Subject: W.P. 163-63-01, Contract No. 74-138
Grading, Drainage, G.B. and Hot Mix Pav.
From Hwy. 6 northerly to C.N.R. Crossing in Simcoe
Highway 24
District 2, London

PROPOSED RETAINING WALL
STA: 349+47 - STA: 350+09, OFFSET 50' LT.
COUNTY OF NORFOLK, TWP. OF WOODHOUSE
HWY. #24, DISTRICT #2 (LONDON, ONT.)
JNT. 74-138; WP: 163-63-01

PROPOSED NEW DAM
HWY. #24, DISTRICT #2 (LONDON)
CONT. 74-138 . WP: 163-63-01

CONT No 74-138
W.O. No 75-16-66
PROPOSED DAM AT SIMCOE
GENERAL PLAN

SHEET
12

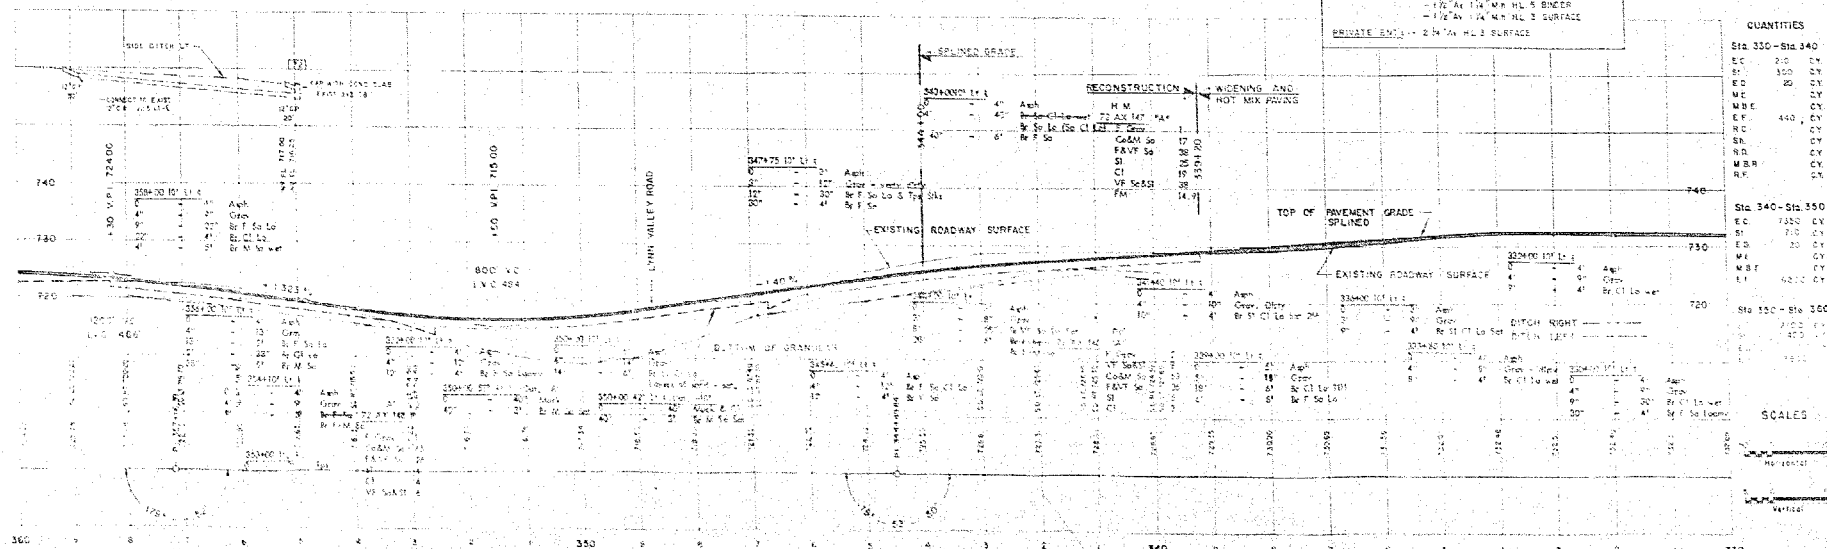
Enclosed are one photocopy each of sheets 1, 5, 12 and 41 of the contract drawings. The approximate location of the retaining wall is marked in red on sheet 12. Attached also are two prints showing cross sections of highway (present and proposed) on sheet 1 and a longitudinal section at 50' west of highway centreline on sheet 2.

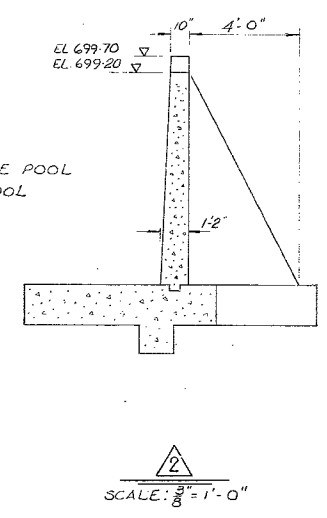
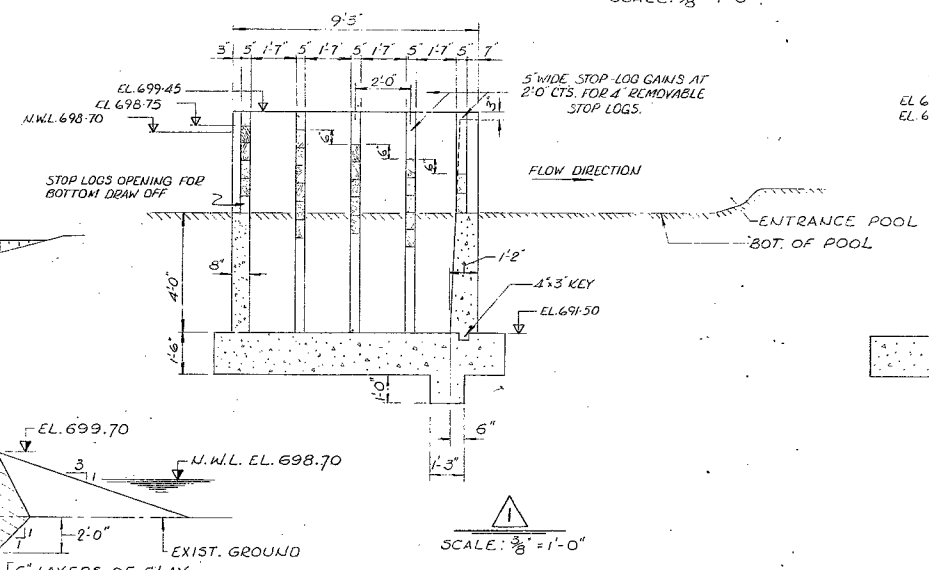
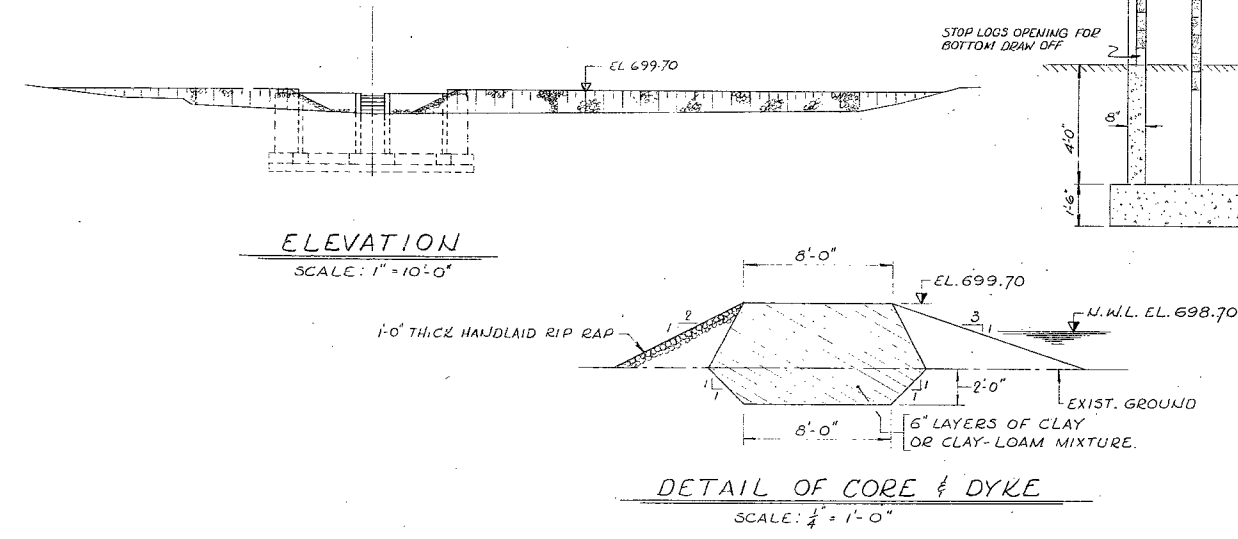
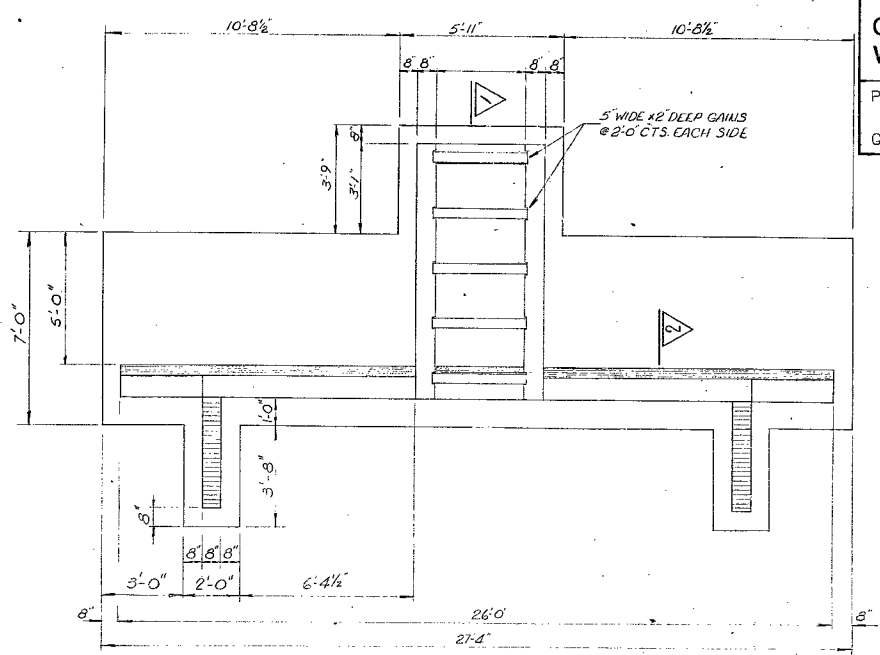
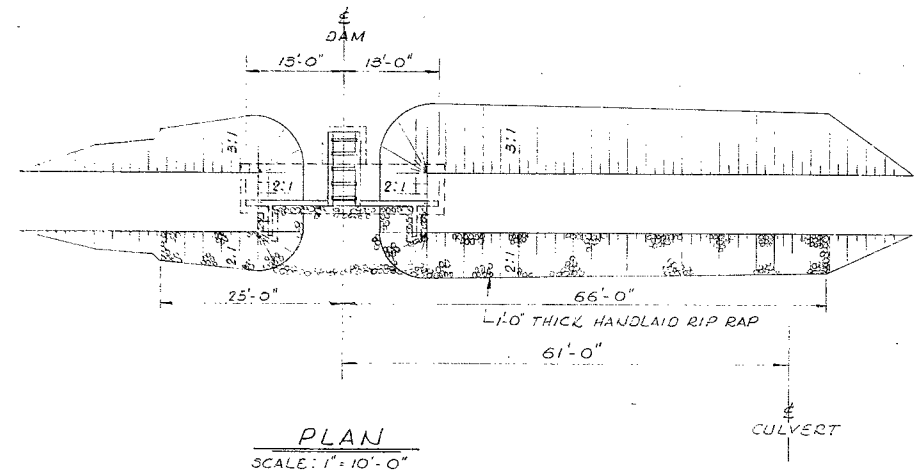
Attached is a print of the proposed dam showing in red the changes required by the Ministry of Natural Resources. I understand that the District is in the process of discussing these changes with the Ministry of Natural Resources and the need for some of these changes is questionable.

The base of the dam foundation should be at Elev. 690 which is slightly below the organic silt deposit. This is about 4 ft. lower than indicated by the afore-mentioned drawing.

1. Excavate the organic silt zone to its full horizontal and vertical extent within the plan limits of the dam footing.

2. Unwater excavation and pour concrete in dry condition. This could be achieved either by an oversize excavation constructed with perimeter ditches and pumping from them or interlocking sheet piles driven to elev. 686±. The unwatering problem can be lessened somewhat by pouring a 4 ft. thick tremie concrete base and constructing the dam on the top as presently designed.

The clay core should be constructed in the dry to ensure satisfactory compaction. Base of core may be placed at 693⁺.

3. Construct a 12" thick pad of granular 'A' under the concrete aprons and extend this pad under the adjoining rip-rap.
